2016 UNITED STATES ROTAX MAX Challenge

BULLETIN 2016-3

Modified regulations: - 2016 USRMC TECHNICAL REGULATION

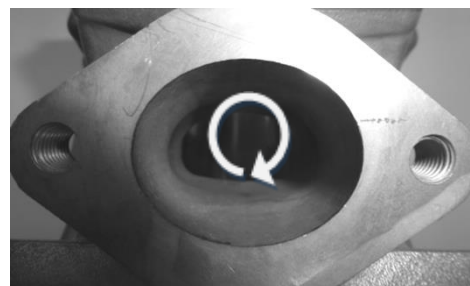
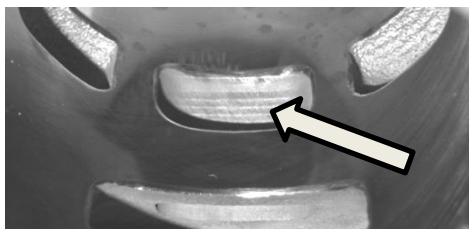
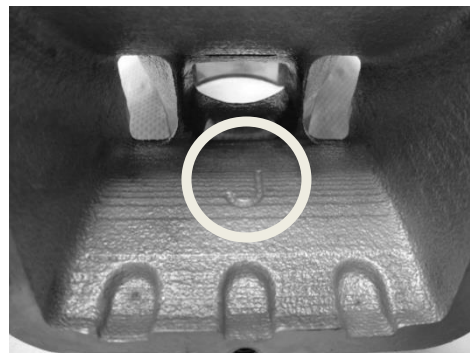
A) In section **5.5 Cylinder**, additional text and pictures have been added:

Cylinders marked 223 994 and showing a cast letter mark (e.g. "J") in the inlet port show a fully CNC machined exhaust port and a fully CNC top edge of the central boost port.

125 Junior MAX and 125 MAX |

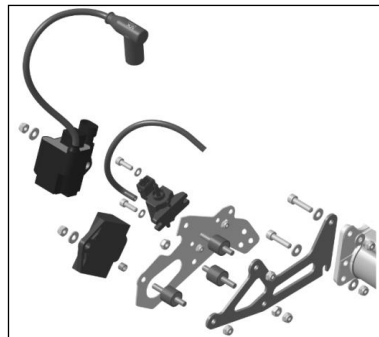
C) Still in section **6.7 Ignition system**: these parts have been added:

Version 2, Dellorto ignition system

Ignition coil (same for all engines) with separate electronic box (ECU, specific for every engine).

Ignition coil and ECU (and magnet valve, for 125 MAX and 125 MAX DD2 only) have to be fitted with all components according to the illustrations below.

Three different mounting versions (left illustration and right illustration) are legal.

In case the mounting bracket (125 Junior MAX and 125 MAX only) is in conflict with a chassis component, the additions of 2 spacers, one per mounting hole, with a maximum thickness of 20 mm between the mounting bracket and the gearbox cover is allowed.

125 MAX DD2

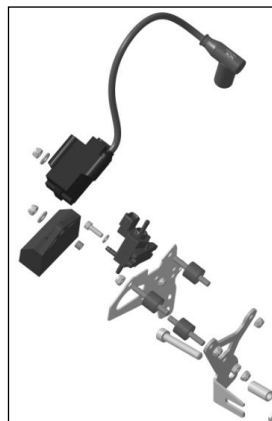
Two different mounting versions (left illustration and right illustration) are legal.

The mounting versions according to the left illustrations are legal to be used until May 31, 2016 only.

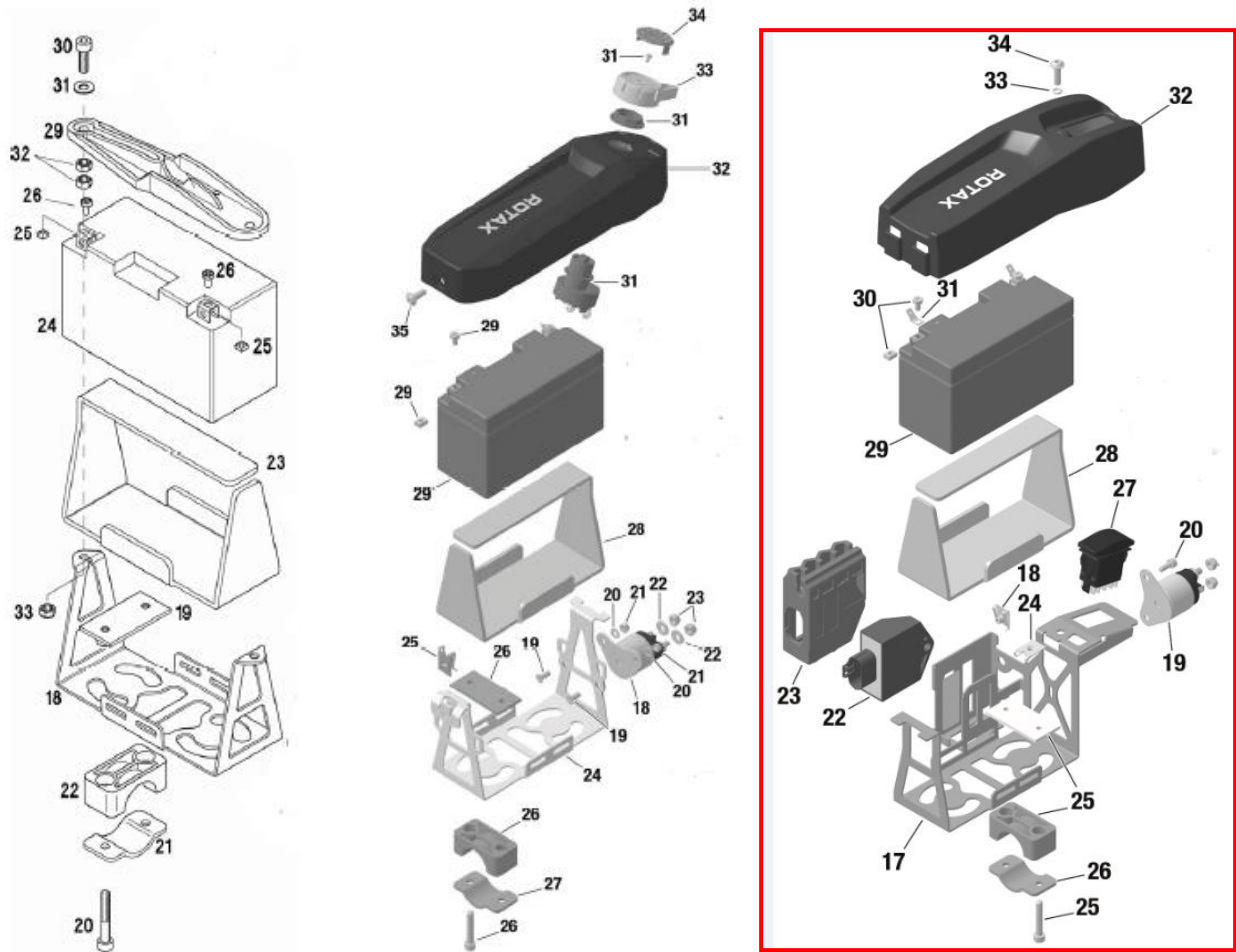
D) Still in section **6.7 Ignition system**, the electronic control unit (ECU) tester software has been upgraded and testing procedure has been modified for :

At every connection with the battery the software version of the ECU tester will be indicated on the display for approx. 2 seconds. The software version indicated on the display has to be 2V00.

After approx. 3 second the type of ECU ① that is actually tested will be indicated in the second line of the display.

After approx. 30 seconds the result ② of the test will be indicated in the first line of the display.

The ECU tester has to indicate following results :
